Contract No. T201507602.01

BR 3-154 on US9 Savannah Road and BR 3-153 on SR1 Rehoboth Avenue over Lewes-Rehoboth Canal
Sussex County

Enclosed is Addendum No. 3 for the referenced contract consisting of the following:

**CONDUIT BLOCK
DIAGRAM II
EAST**

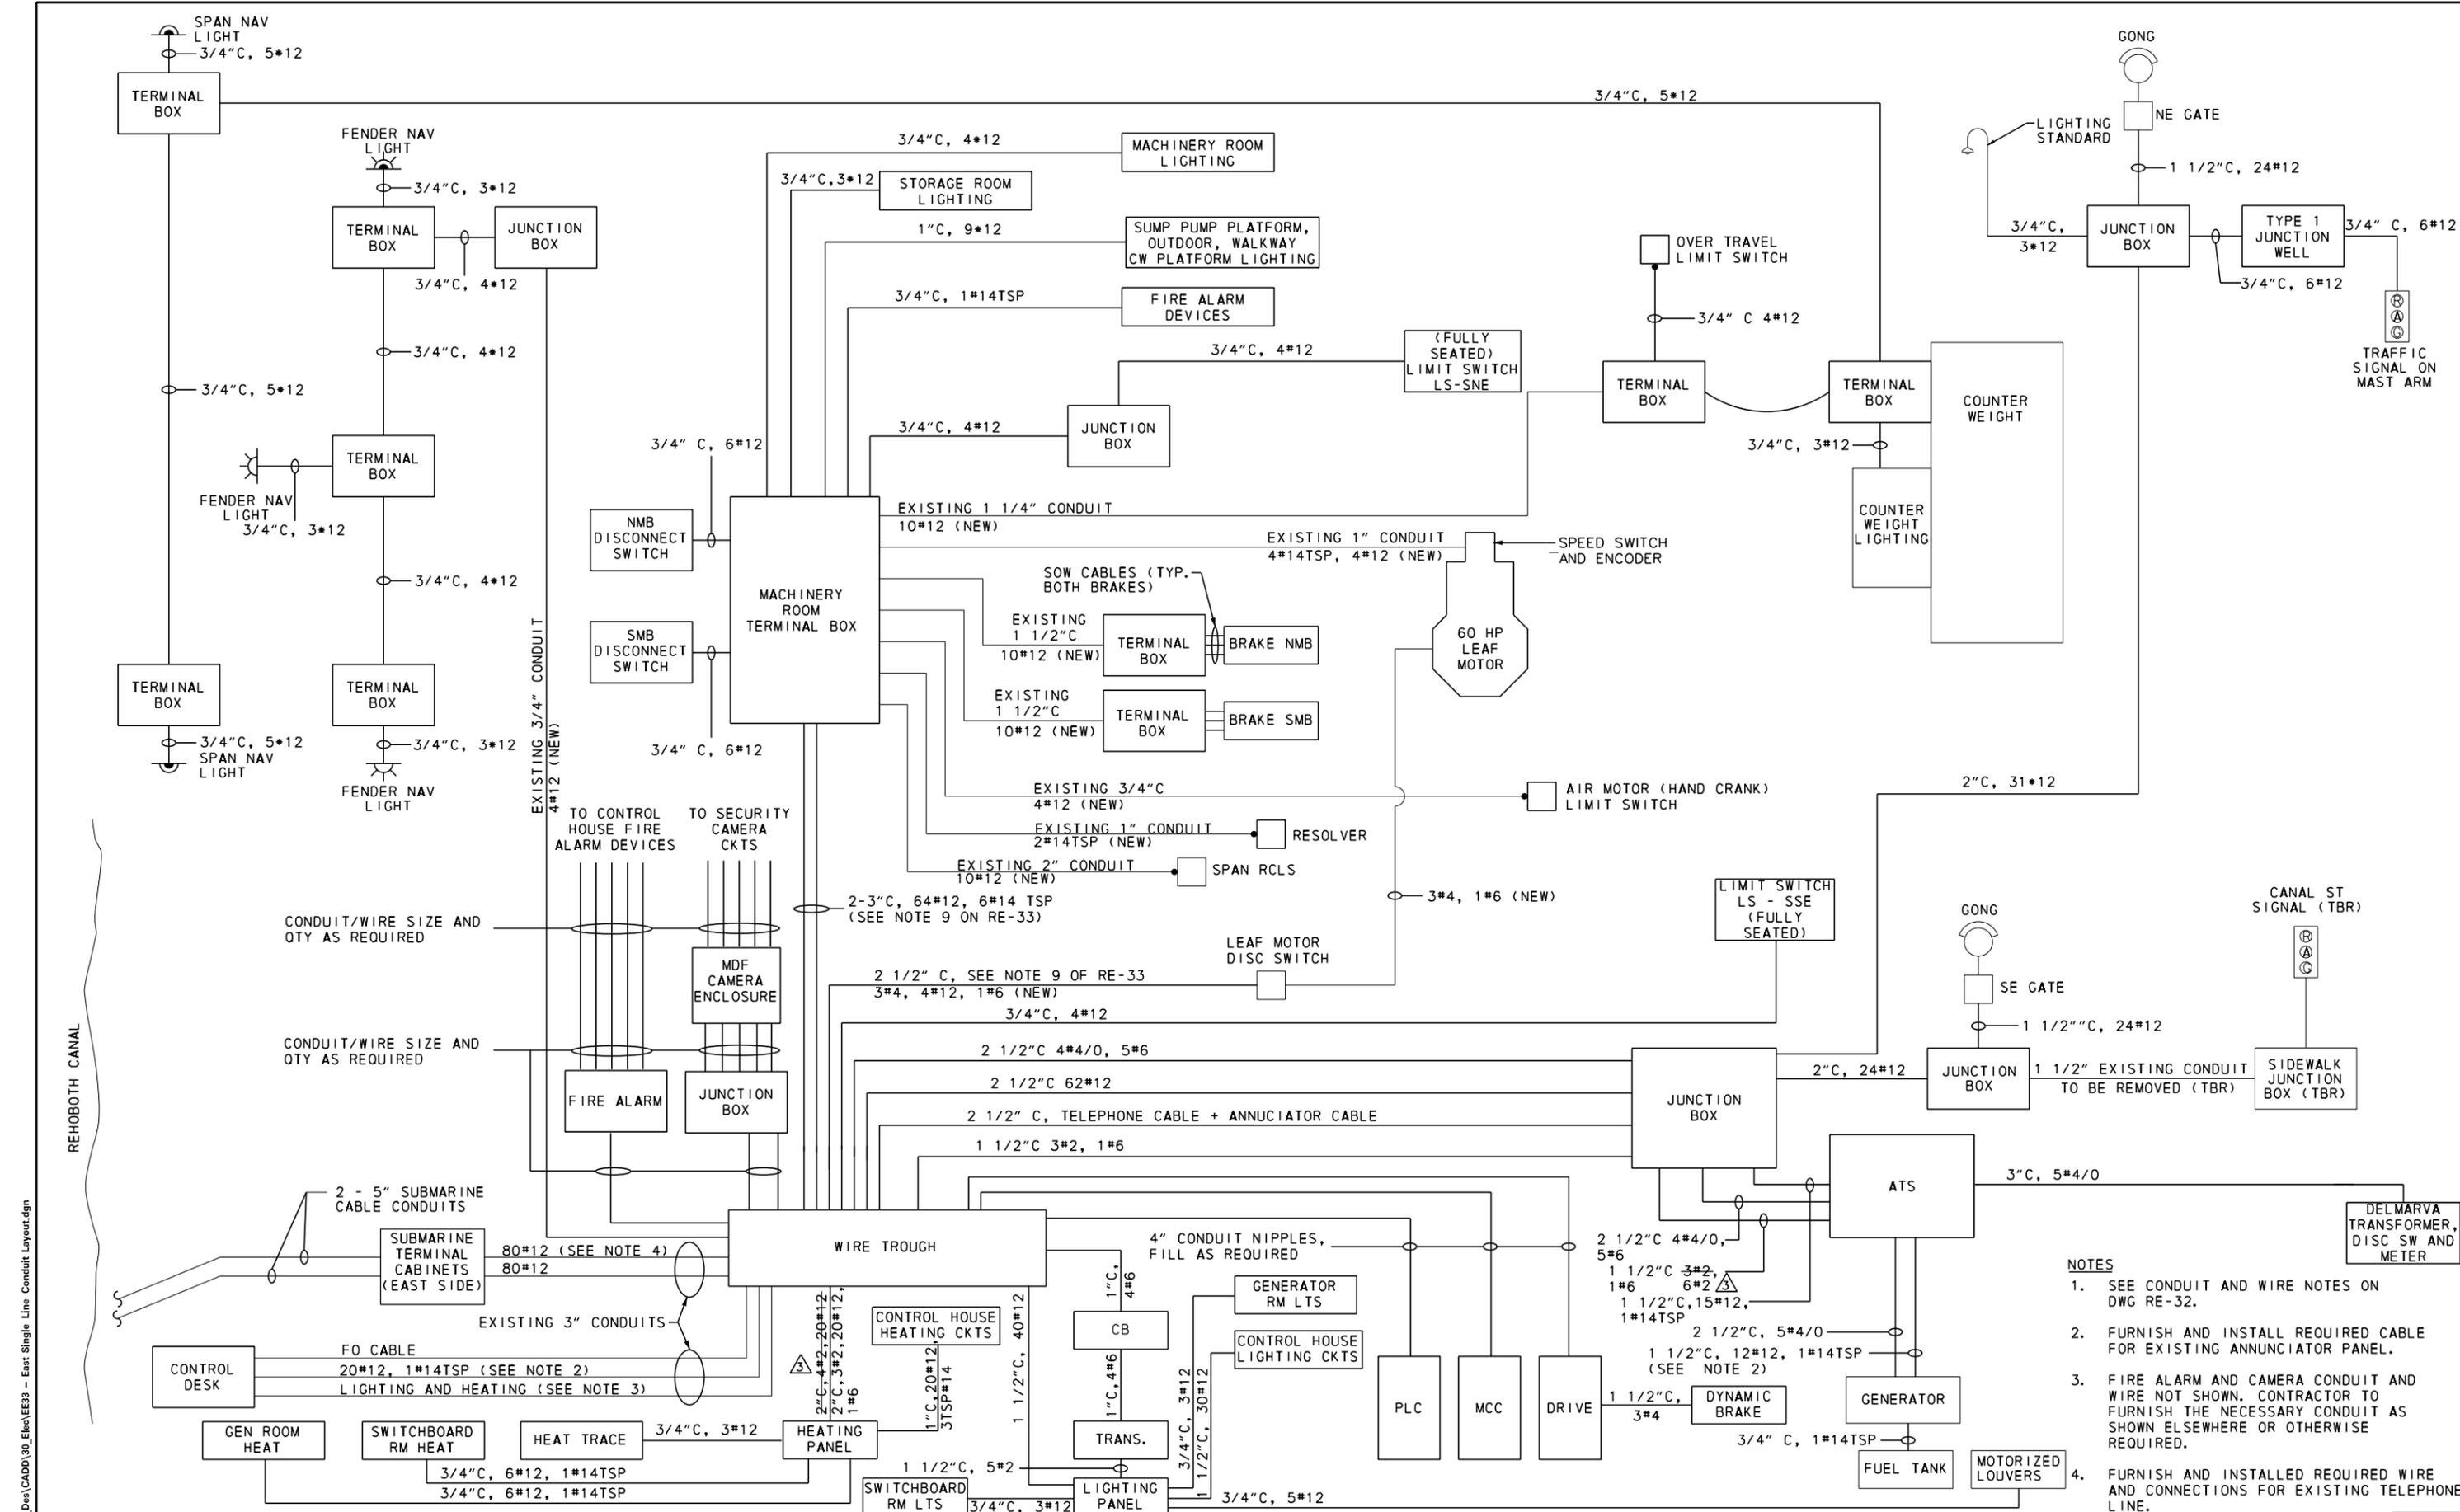
ADDENDUMS / REVISIONS	
△	ADDED WIRE AND CONDUIT (MJT 7/23/18)

SE-5
SHEET NO.
119
TOTAL SHTS.
180

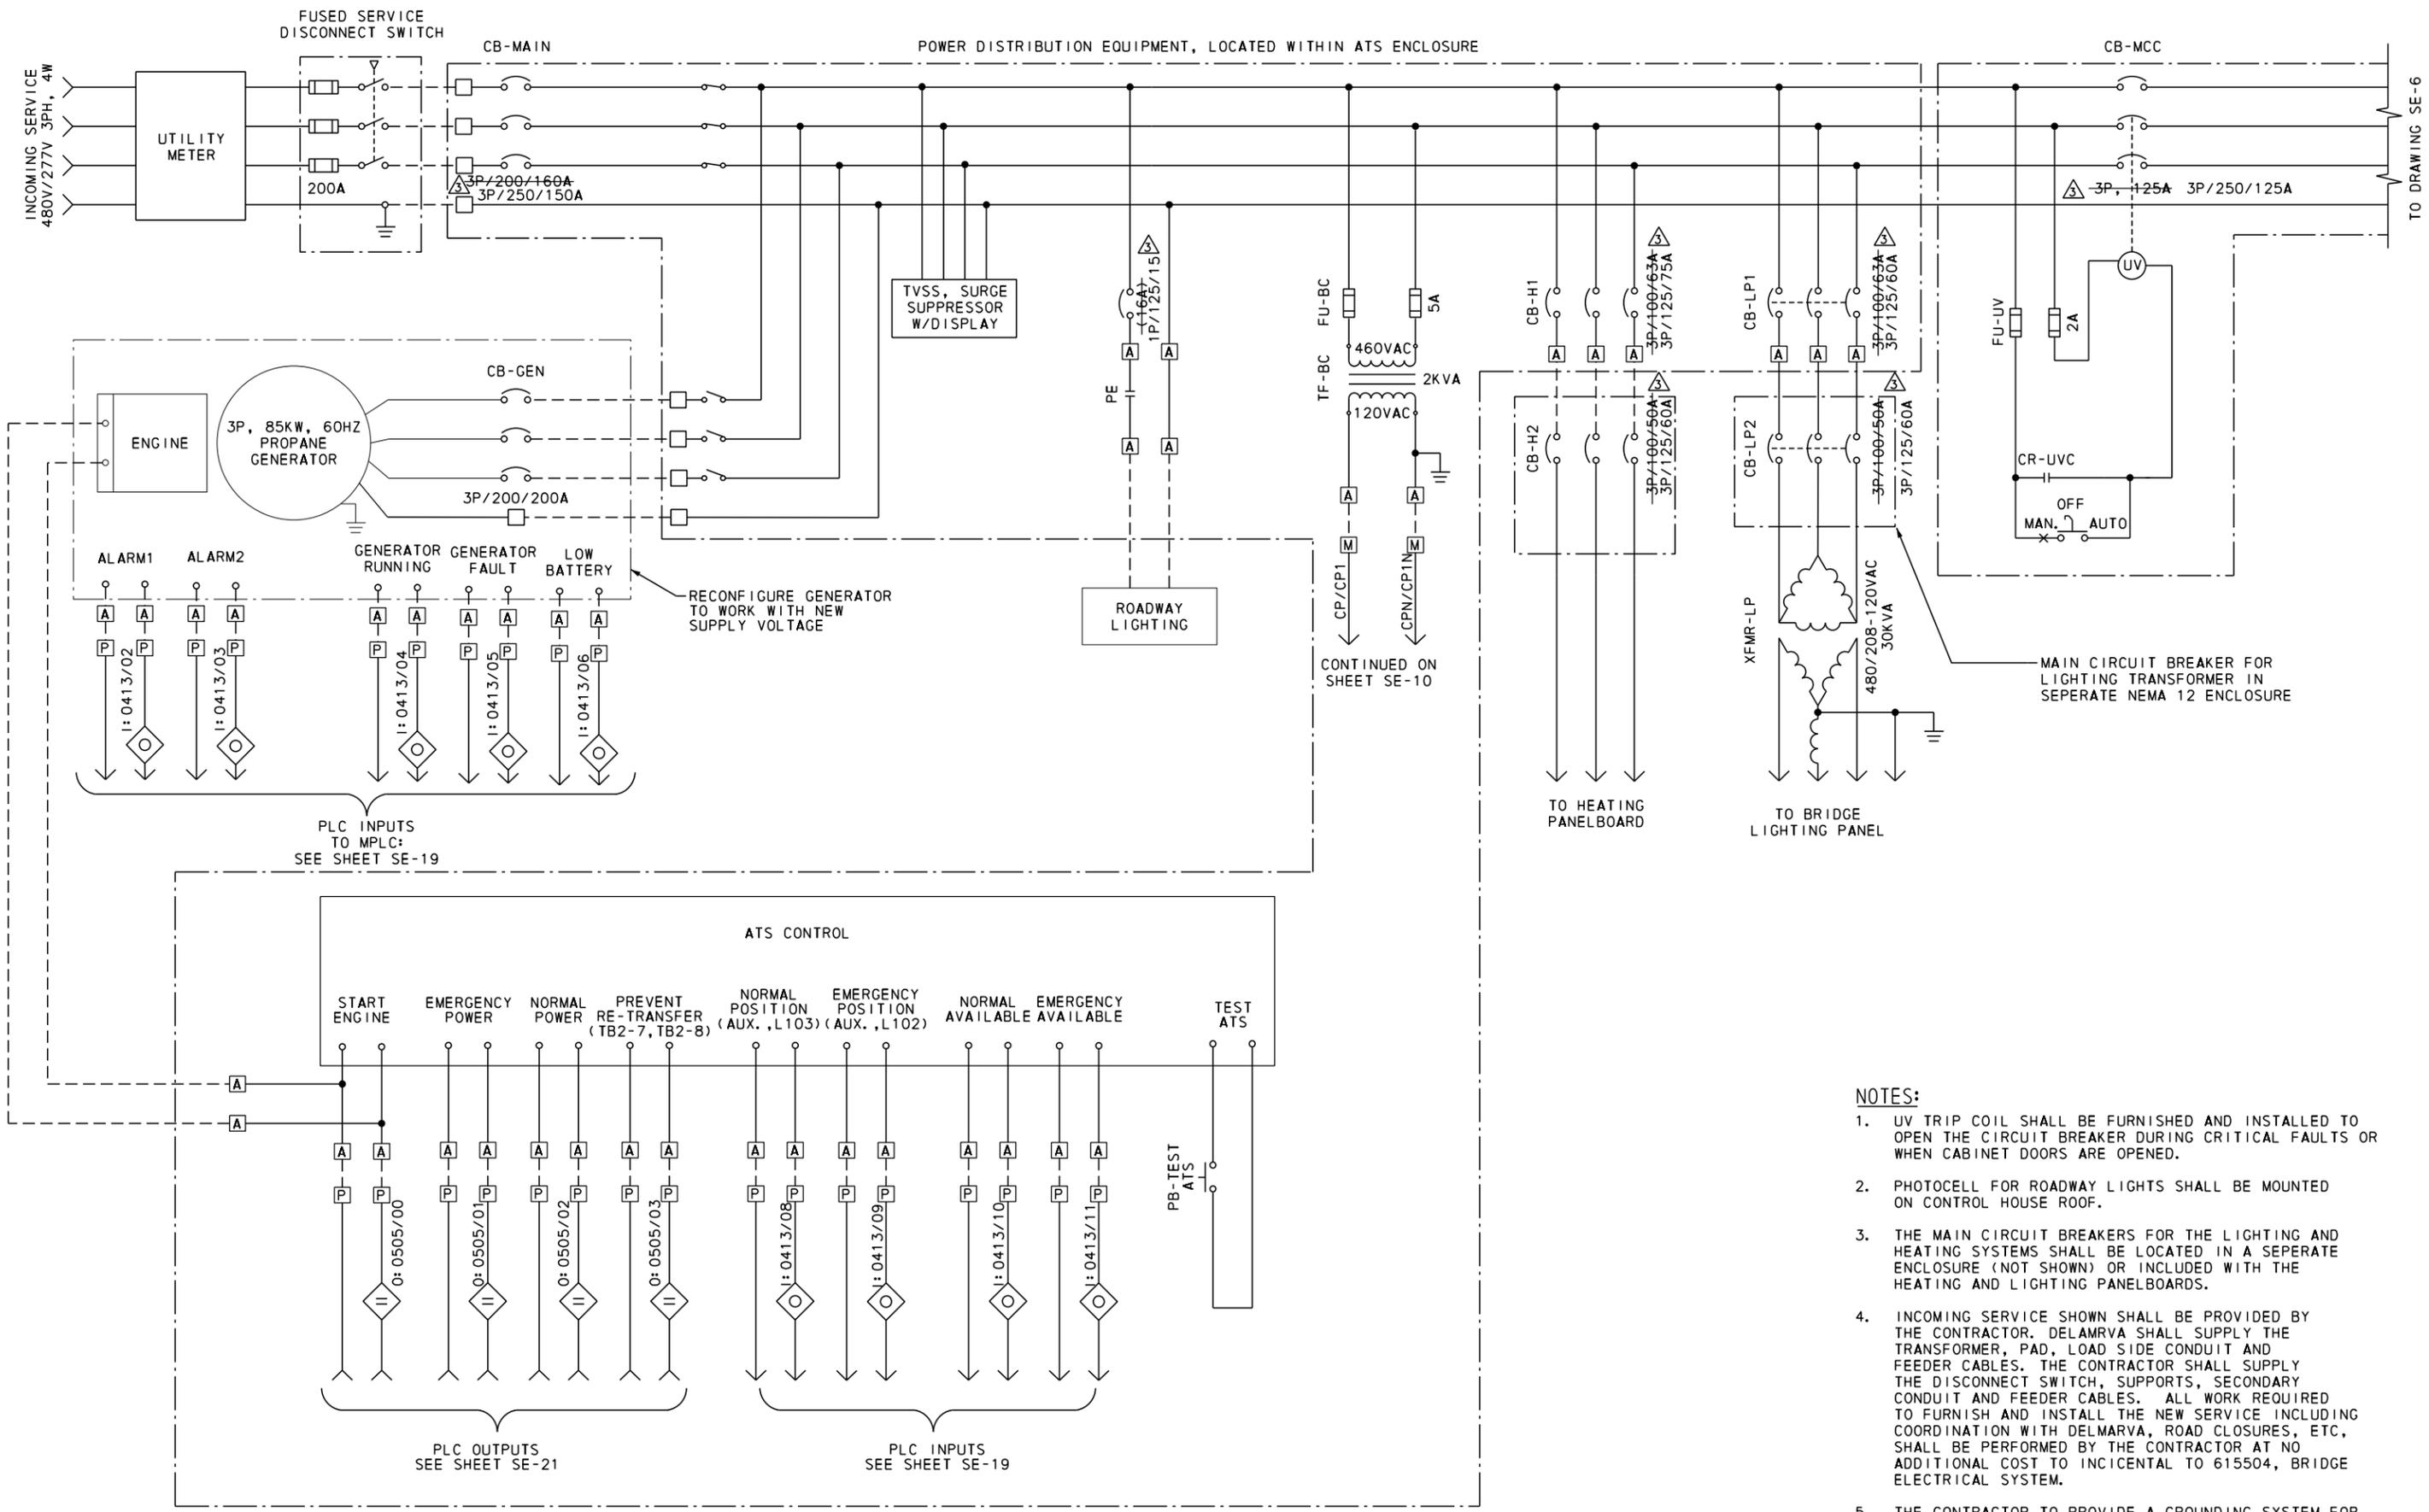
ADDENDUMS / REVISIONS	
Δ	MODIFIED CIRCUIT BREAKER SETTING (MJT 7/23/18)

SE-7
SHEET NO.
121
TOTAL SHTS.
180

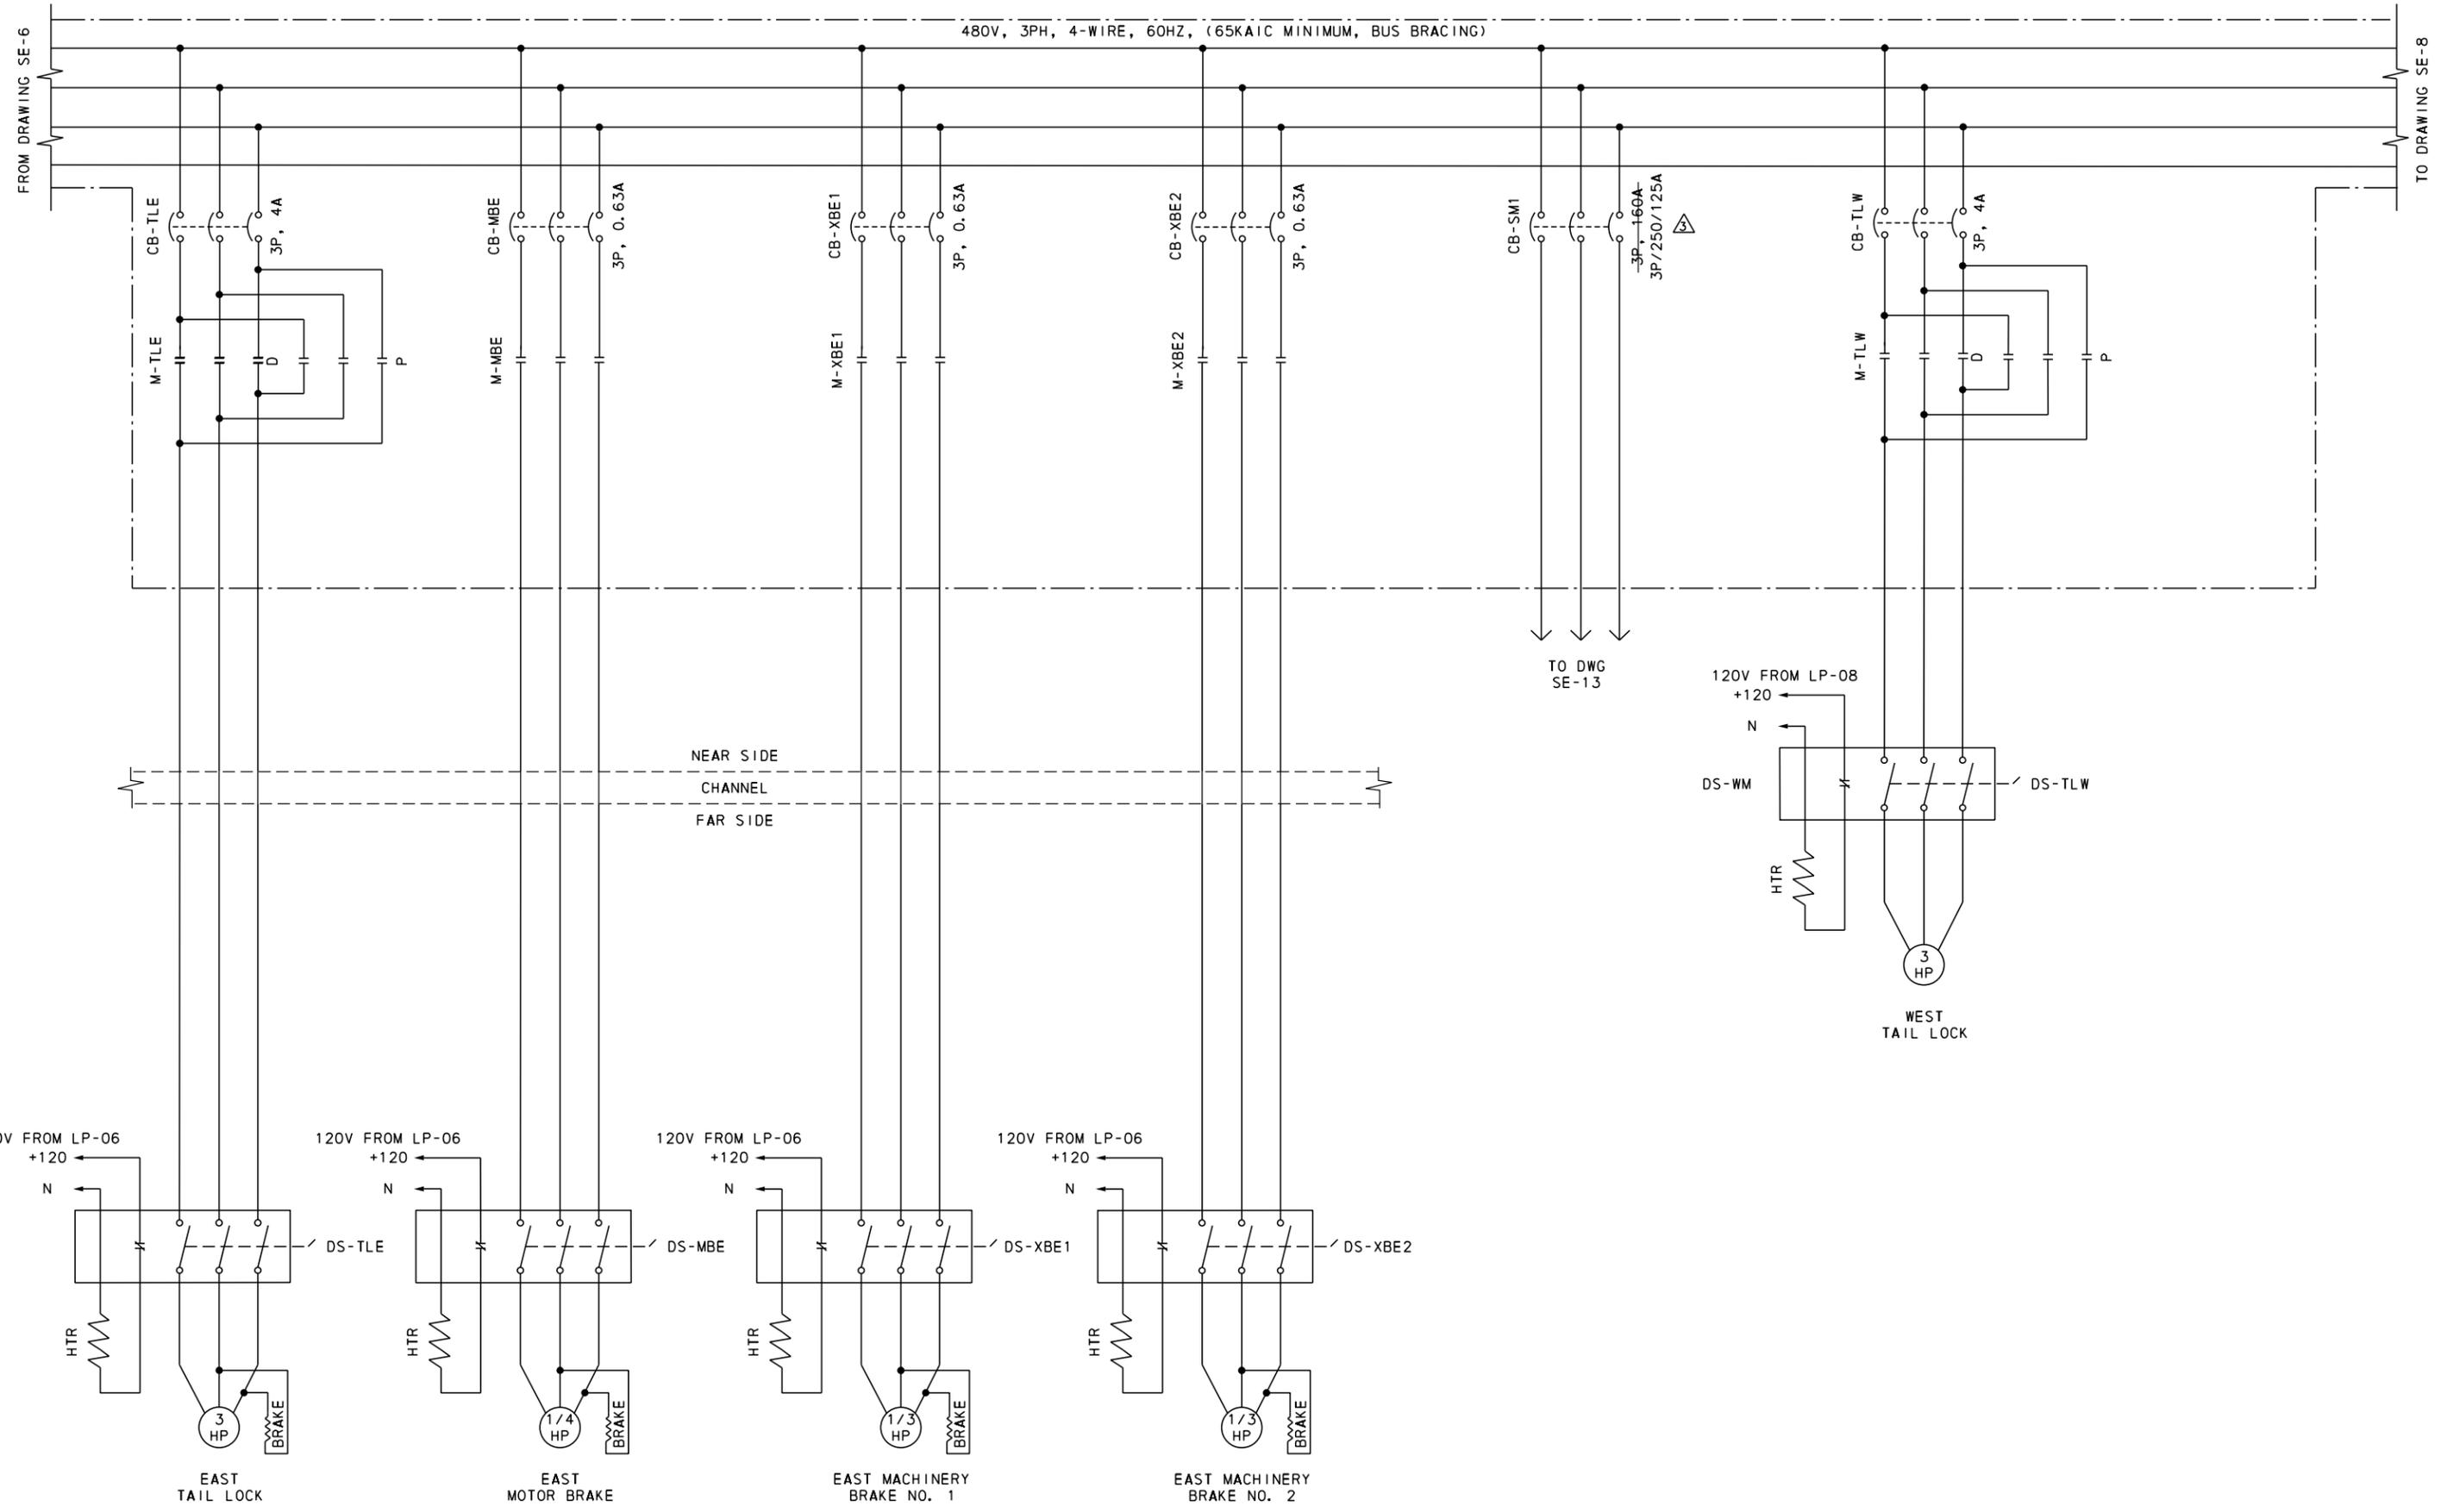
ADDENDUMS / REVISIONS	
△	MODIFIED CIRCUIT BREAKER SETTING (MJT 7/23/18)
